## Caldecote PC Sub-Committee EWR Notes

### 1) **AGAINST** - North Cambourne Station - Alignments 1(Blue) & 9(Purple)

Figure 1 Route of Alignments 1&9 through Highfields

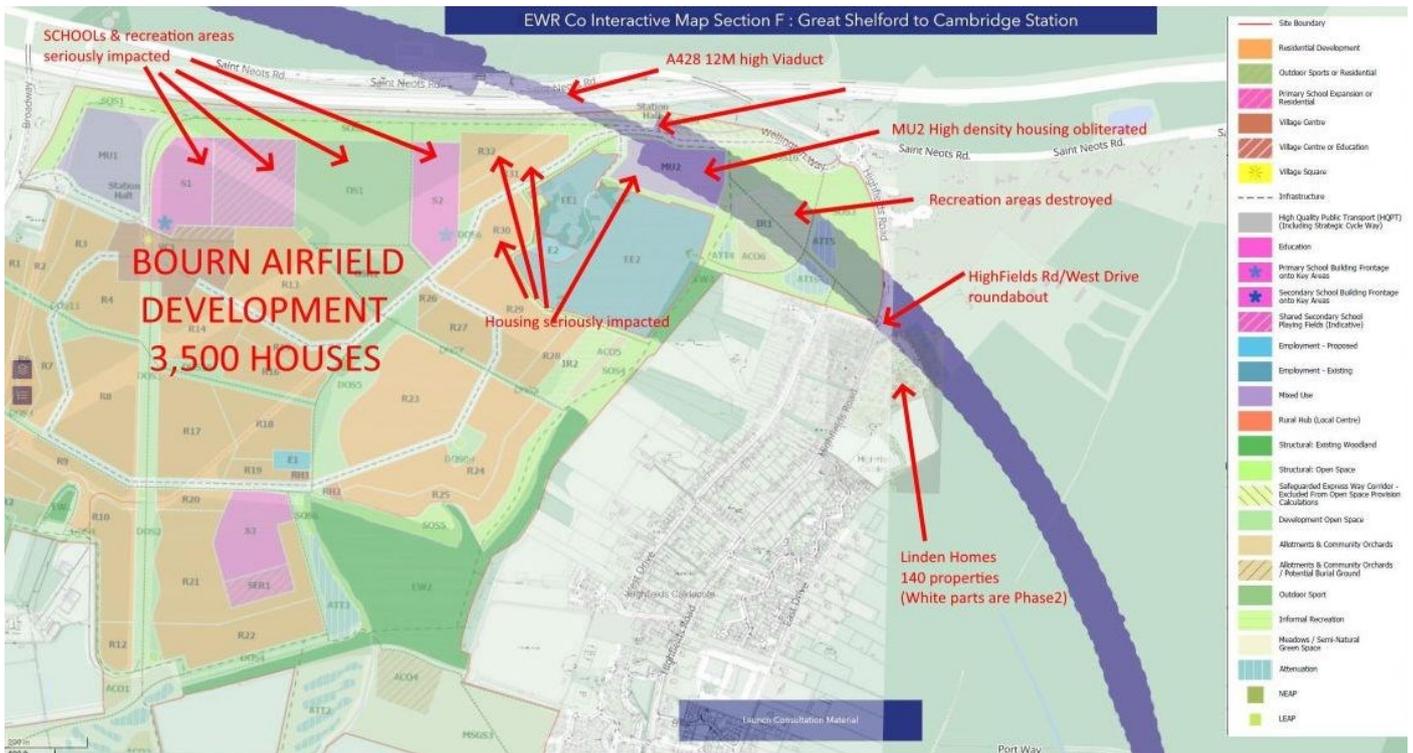
iii) No real account has been made to the pollution, noise and visual impacts on the inhabitants of West Drive, Highfields Road, Highfields Court of a 12m high 80M+ wide embankment, or the possibility of severance further down towards Hardwick and Toft/Comberton. No-one needs reminding that this is a route to our village college.

- *Having to rise up an additional 12 meters on a hill that is already some 72M high has a disproportionate visual, noise and pollution impact on the surrounding area.*

iv) No account has been made for the severance of the entrance of Highfields and its main access to the old A428.

- a) Due to the proposed height and its impact on 2 communities the only sensible mitigation would be to tunnel under the A428.
- b) Across the field it should be in a cutting below ground, just as is offered to the Broadway on alignments 2 & 6. This should extend to behind the woods at the back of Angel Park.
- c) Where it cuts Highfields Road and the track to Highfields Farm & its Public Right of Way there should be bridges constructed over the cutting at ground level.
- d) Pedestrian and cycling access should be offered by similar bridging across the field as per the paths detailed by the approved Bourn Airfield Development plan

Figure 2 Route of Alignments 2,6 & 8 through the Broadway at Bourn

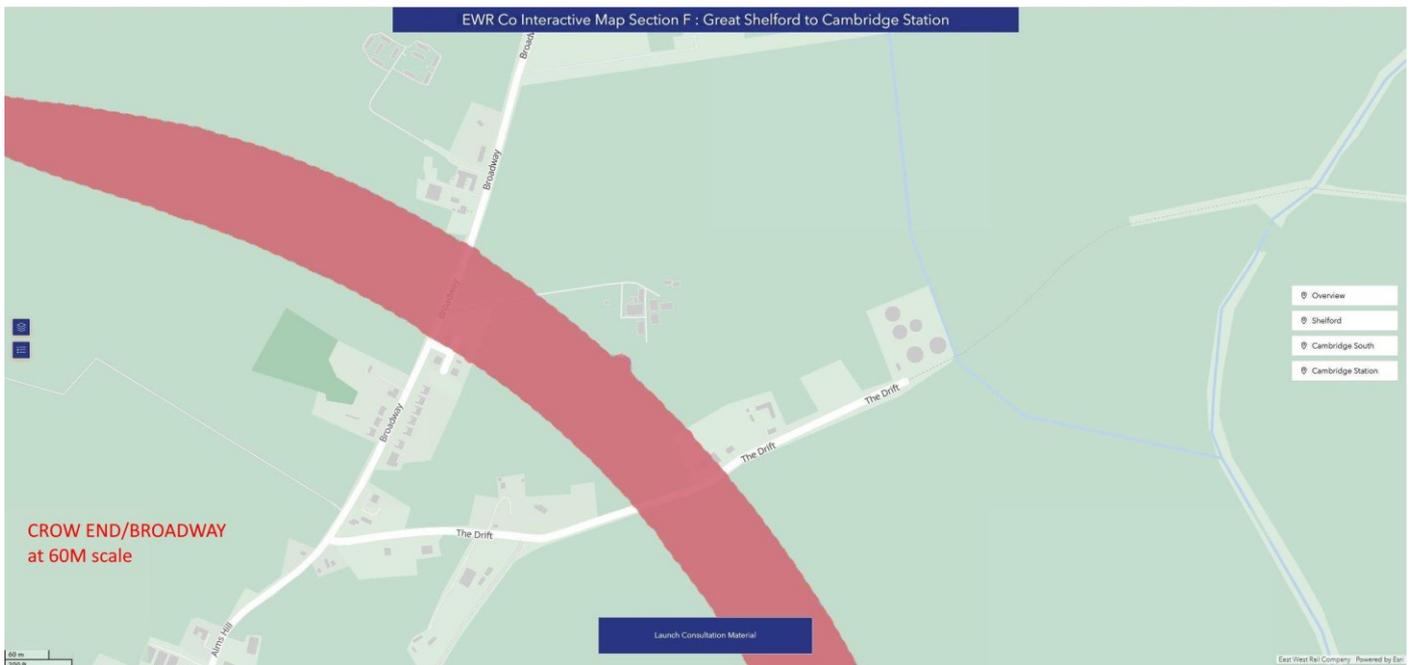
- c) Much is made of the fewer properties demolished (4) if Alignments 1 or 9 are followed. But they haven't accounted for both the Angel Park demolitions (another 9+) and the considerable impact on the new Bourn Airfield Development community. Alignments (2&6) will have much less impact since fewer properties (9) will be demolished and there are fewer houses (roughly 34) within 200 M.

- e) The railway would follow the terrain down the hill from a Cambourne South Station, having less immediate visual impact. More noise will be absorbed because it follows the side of the hill, partly in a cutting and, in general, is lower during its descent from the Hill than alignments 1&9.
